COMMONWEALTH OF KENTUCKY
BEFORE THE ELECTRIC GENERATION
AND TRANSMISSION SITING BOARD

Case No. 2024-00105

PIKE COUNTY SOLAR PROJECT, LLC'S RESPONSE TO
SITING BOARD'S FIRST DATA REQUEST

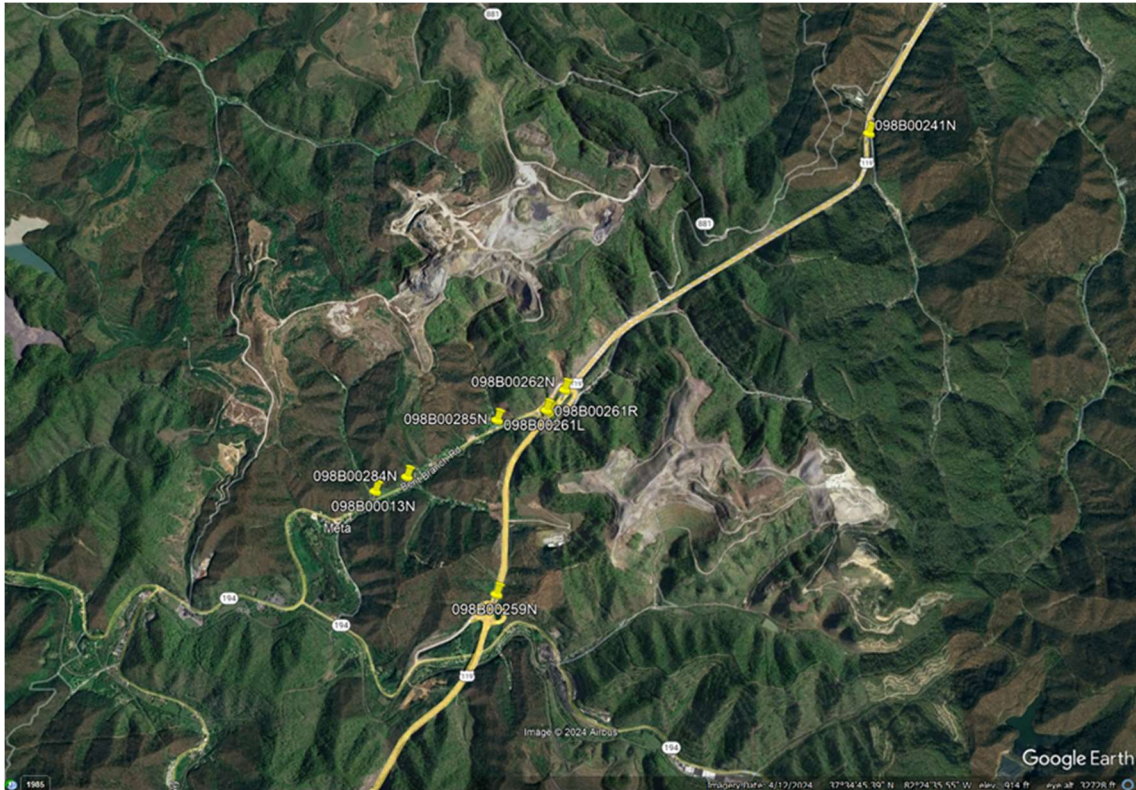
37. Refer to the SAR, Exhibit E, Traffic Impact Study, Figure 1, Vicinity Map. Provide the location and weight limit ratings for any bridges within this Vicinity Map area.

RESPONSE: The clip below shows the bridges in the area of the vicinity map. The table below shows these bridge locations and weight restrictions. Weight restrictions on any additional bridges can be found using KYTC’s Bridge Weight Limits interactive map. Note that these restrictions will periodically update and change, so the Project anticipates checking back with the interactive weight limit map as part of the pre-construction process.

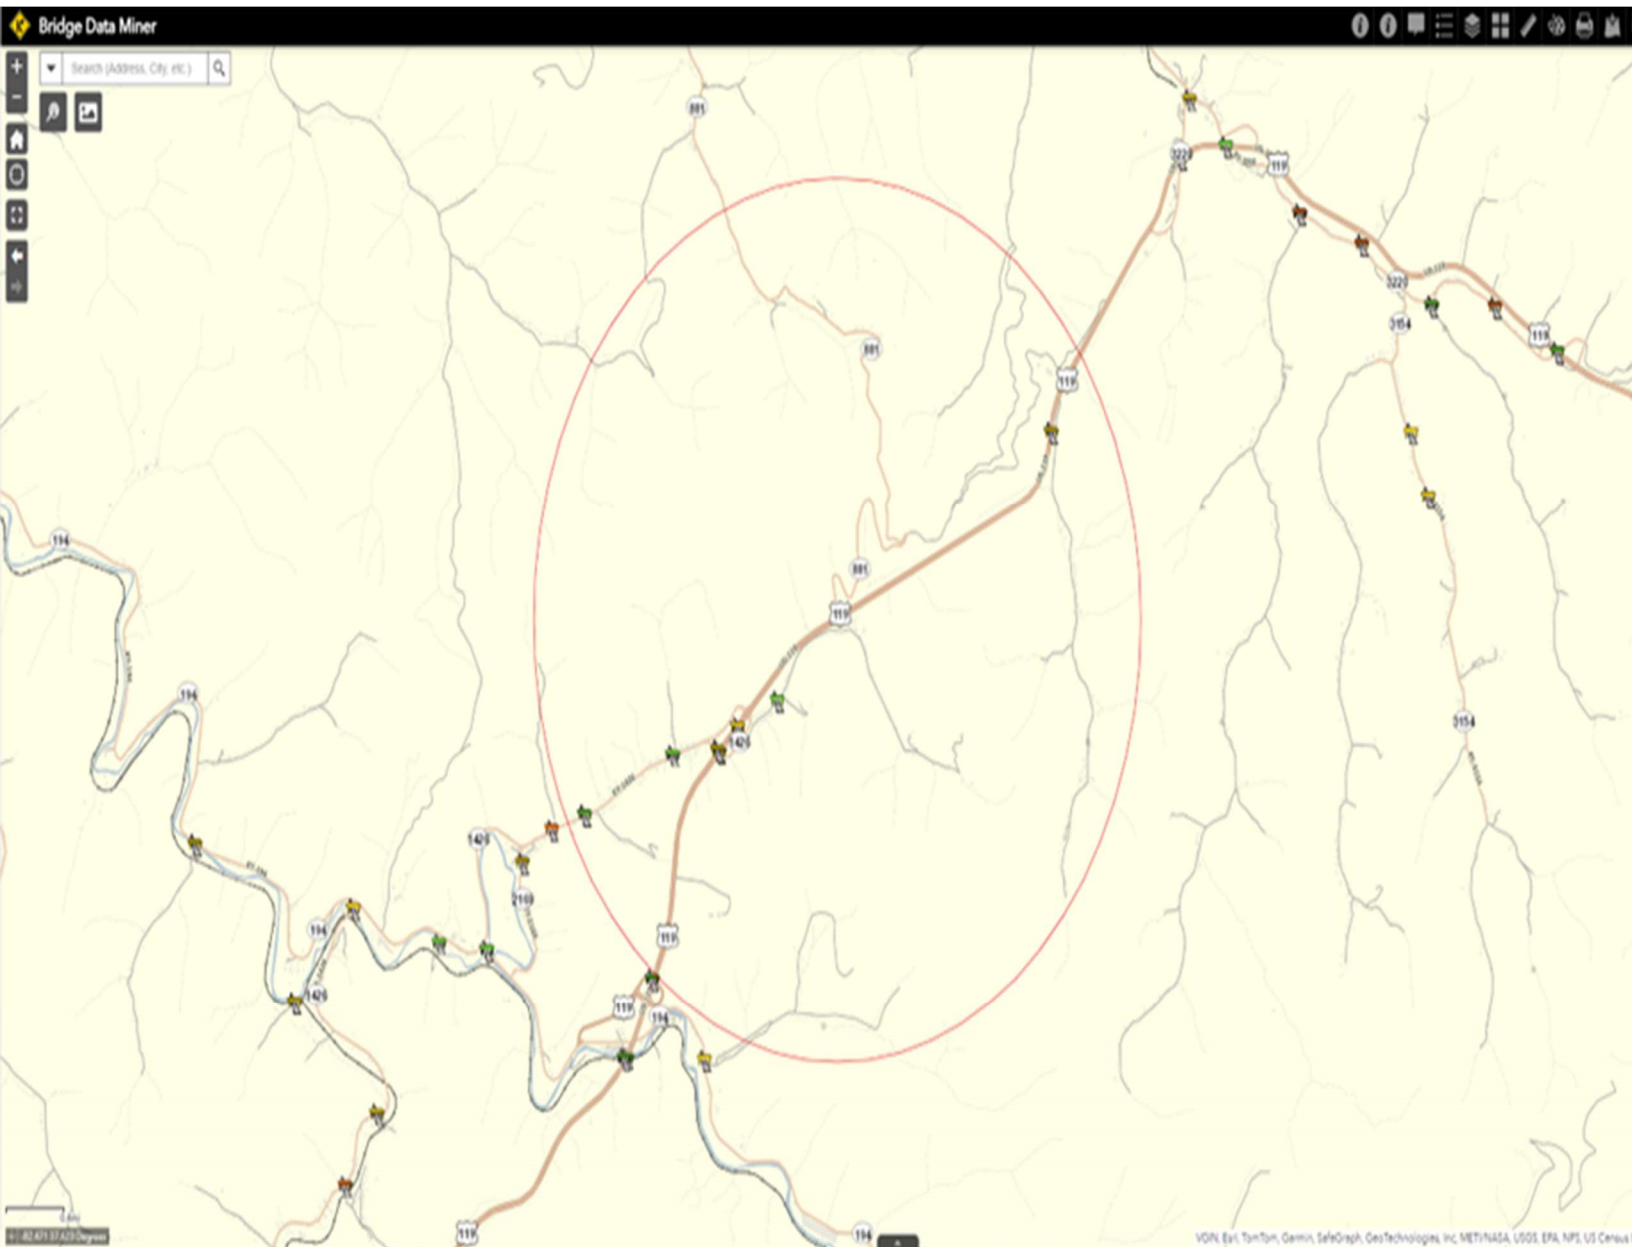
43. Identify any bridges within a two-mile radius along KY 881 (Brushy Road), KY 1426 (Bent Branch Road), and US 119. Provide a one-page map depicting the bridge(s), if any.

RESPONSE: The map below depicts the bridges within a two-mile radius from the intersection of KY 881 with US 119.
